Product Change Notification

Date Issued :
 March 09, 2022
 PCN Number :
 511785

Description of Change: This notification is to inform you about the Obsolescence of parts(s) referenced in this notice. Please

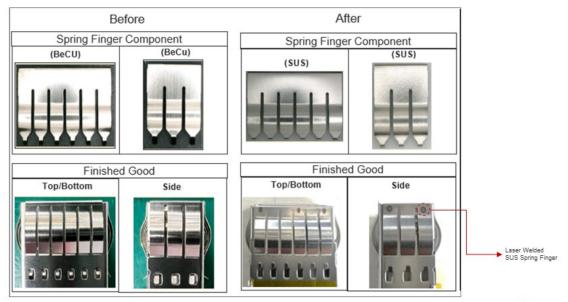
- Please be advised that the following Part numbers from the QSFP+/ZQSFP+ Ganged cages product families are being made Obsolete with replacement. The spring fingers of the offered replacement parts will be made of Stainless Steel & will also undergo laser welding during the assembly process.
- Reason for Change

Critical shortage of Beryllium Copper which is the raw material used in spring fingers of the affected parts.

Spot welds will be the only effect to the form, no impact on fit or function based on test summary 1000143001 (available upon request).
